Design Amendments

| Rev | Description | Date | By | Client | Scale | Drawn by | Checked by | Rev |
|-----|--|----------|----|--------------------------|----------------|----------|------------|-----|
| | | | | Eric Parry Architects | EPA QGR 03_105 | | | |
| | | | | Proposed Long Section FF | P4 | | | |

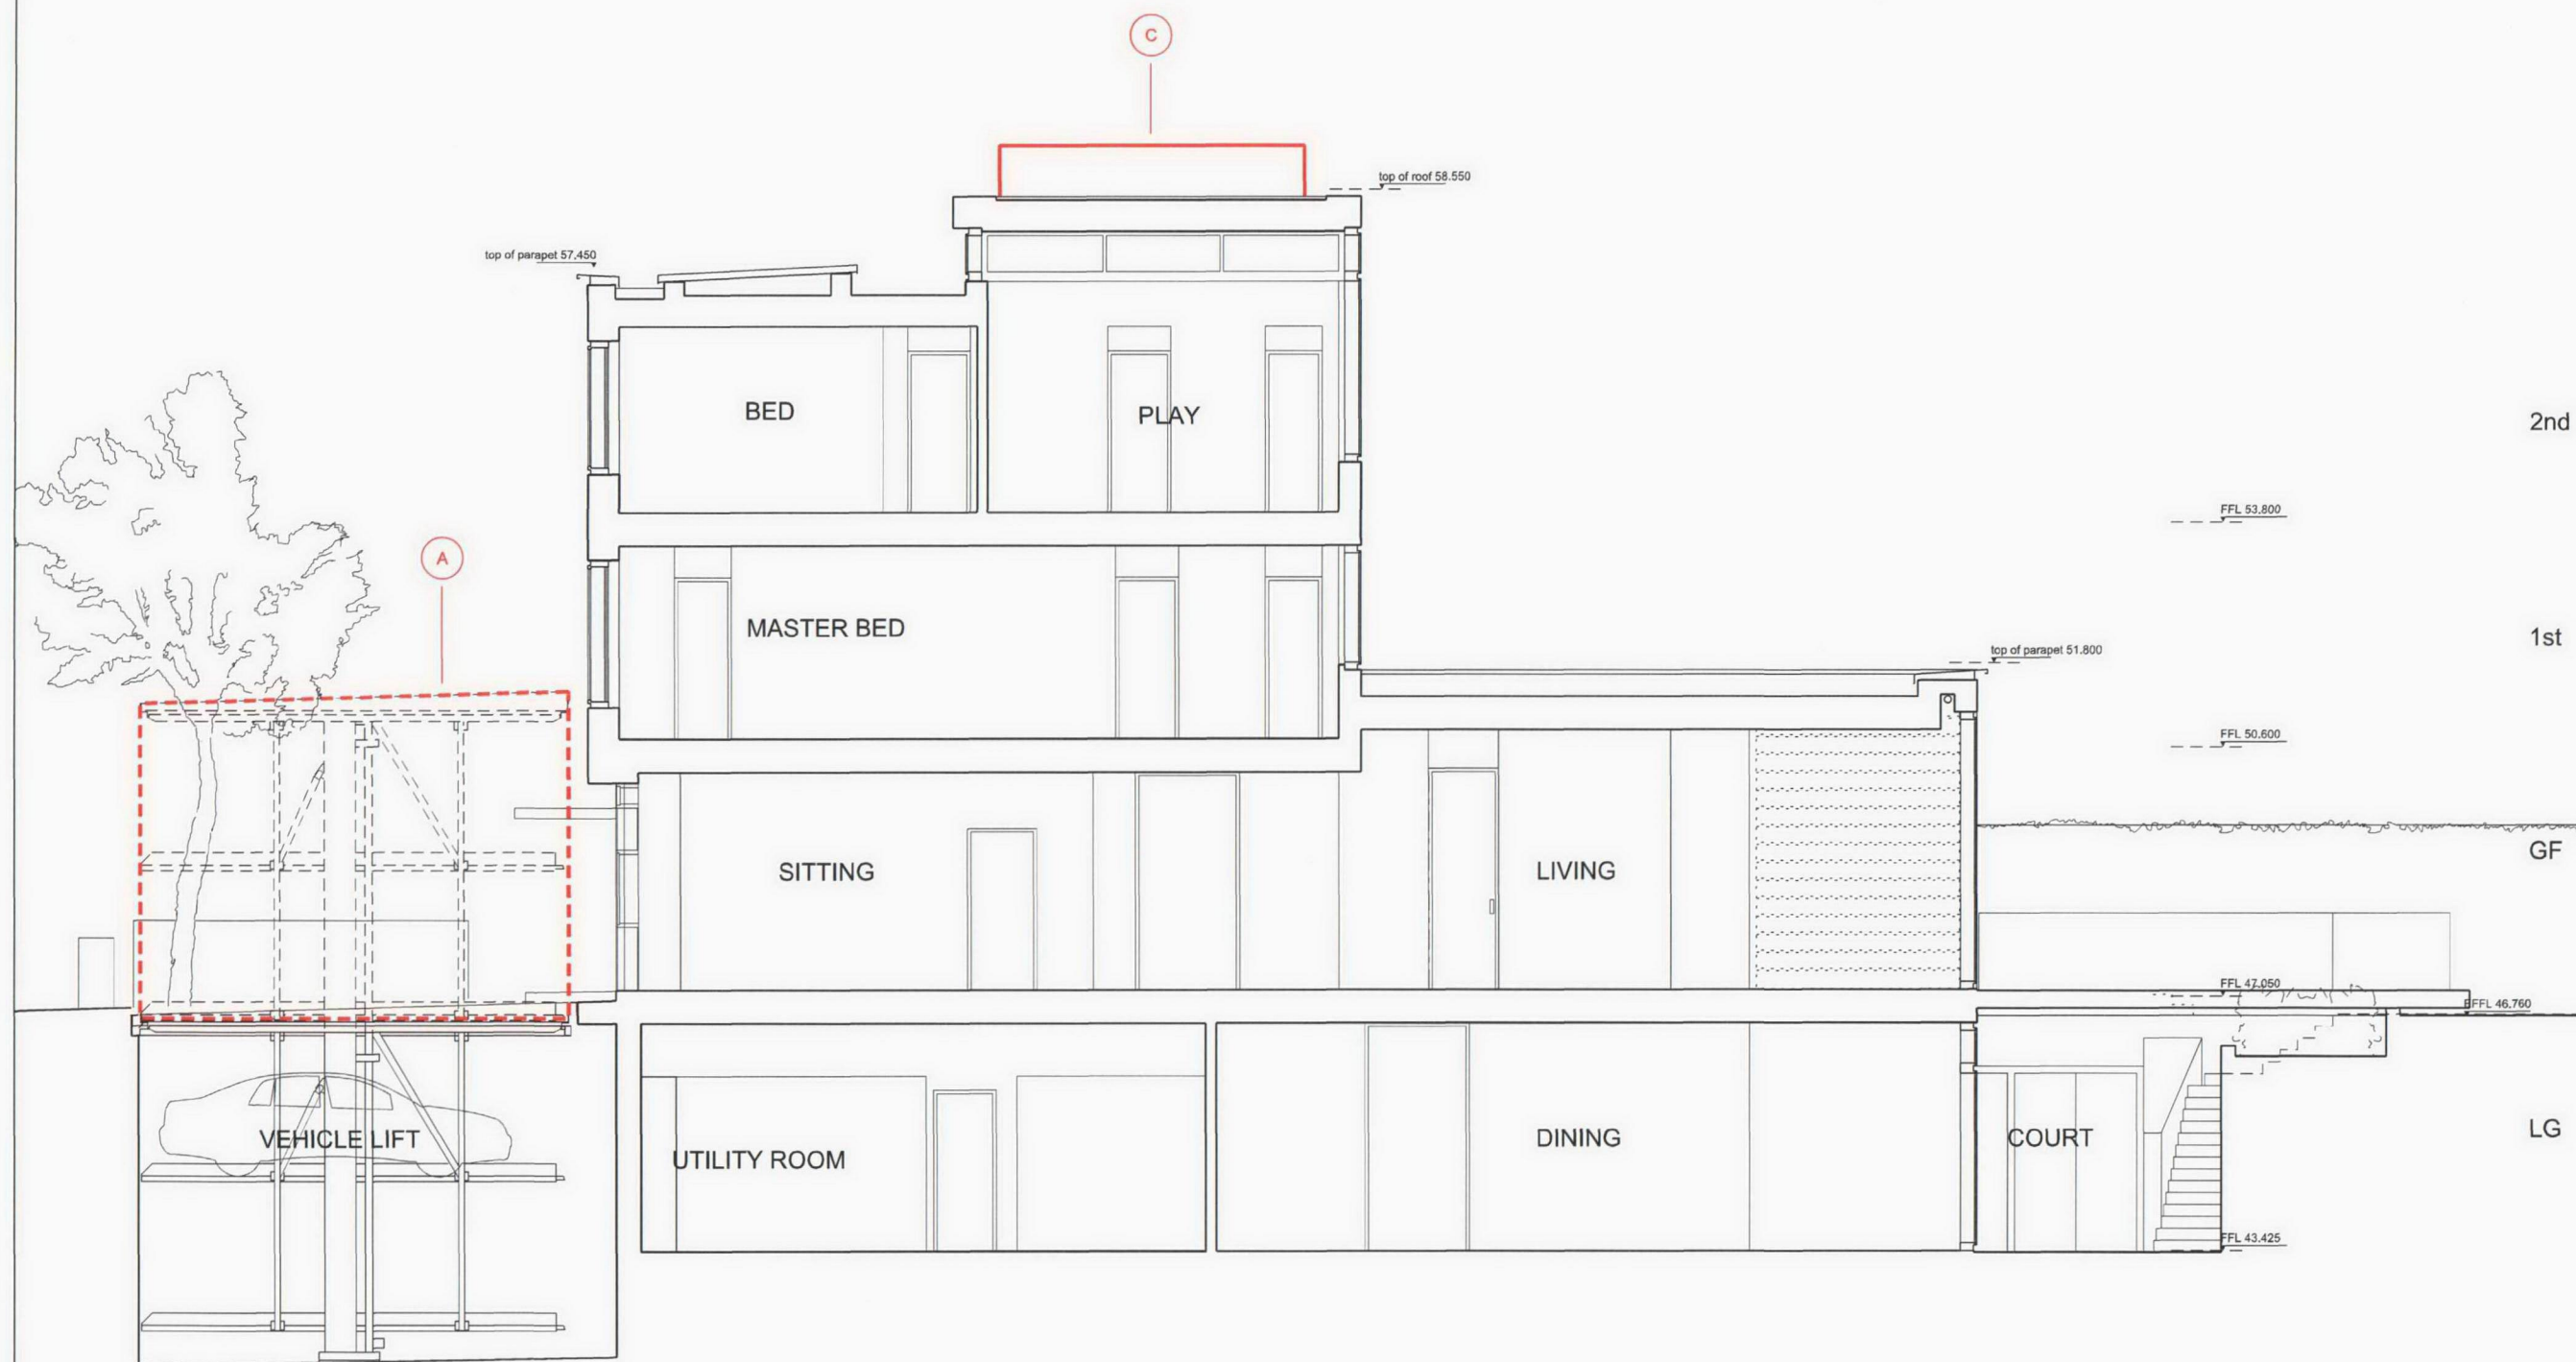
A The double width car lift has been replaced with a double stacker (one above another). The opening in the low boundary wall to pavement can also now be narrowed.

C Introduction of a roof top air source heating and cooling in lieu of the combined ground source and heat rejection units at application. The form of the louvred enclosure is curved so it diminishes in street and garden views and about the same height as the chimneys of the neighbouring villas.
